Technical considerations for the limit setting

36th TF TA
7th July 2025

JAPAN AUTOMOBILE STANDARDS INTERNATIONALIZATION CENTER

2. COVA test : Variability Analysis of Vehicle method

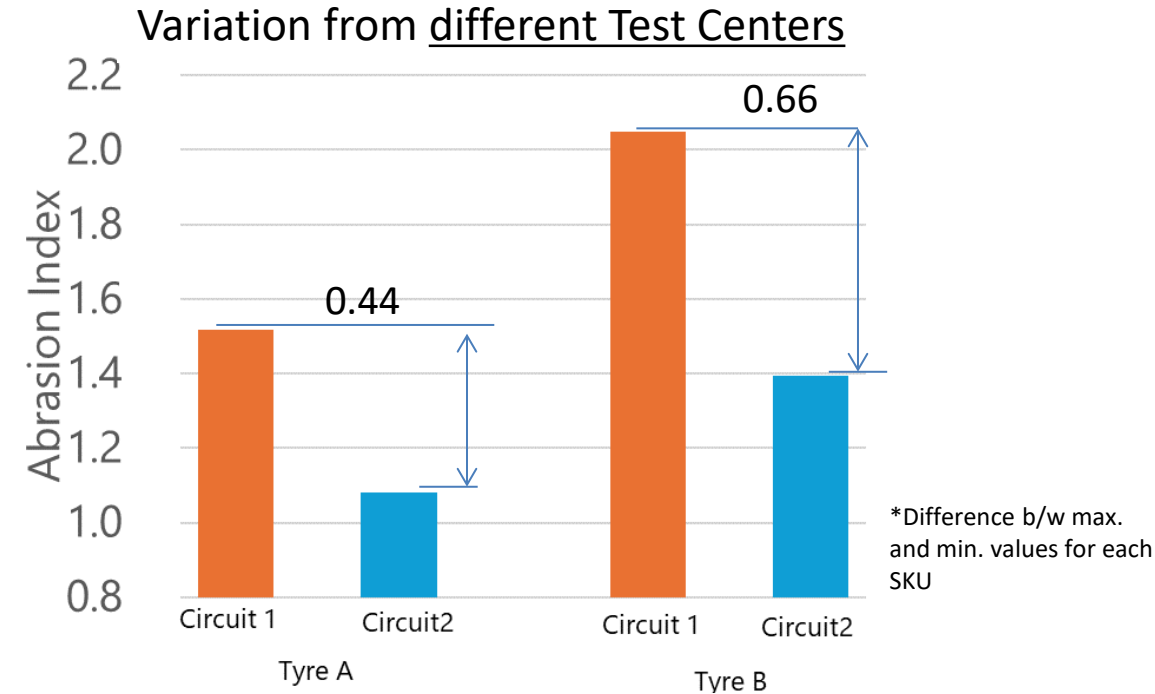
- ✓ Result variation of up to 0.43 even in the same TC.
- ✓ The cause of this variability is unknown.

- ✓ Result variation of up to 0.66 between TCs.
- ✓ The cause of this variability is unknown.

- ✓ **Variability in the results of vehicle tests has been observed both within TC and between TCs, and the causes of this variability have not yet been identified.**
- ✓ **To investigate the potential causes, it is necessary to collect and review detailed records of the test conditions used in the vehicle tests (ref. TAPP-22-2)**

Ref. TA-33-8v1

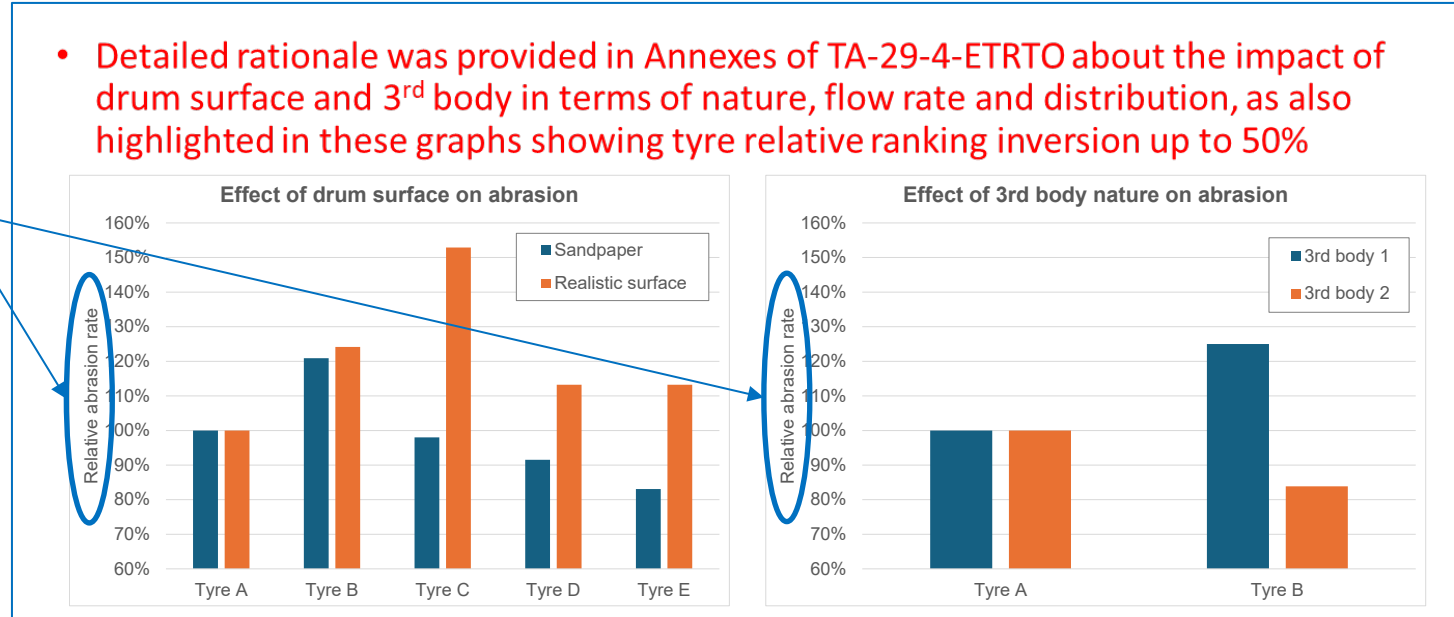
- In TA-33-8v1, ETRTO commented that tyre relative ranking inversion of up to 50% can occur, but this is based on the “Relative abrasion rate” calculated by ETRTO, not on the Abrasion Index.

- ✓ Tyre abrasion is evaluated based on the Abrasion Index; therefore, the proposal to delay the limits setting for the drum test method by nine months on the grounds of a 50% difference in “Relative abrasion rate” is excessive and unacceptable.
- ✓ Since TF TA is in the important phase to discuss abrasion limits. We would like to propose this kind of discussions be held at the TF TA after the September GRBP.
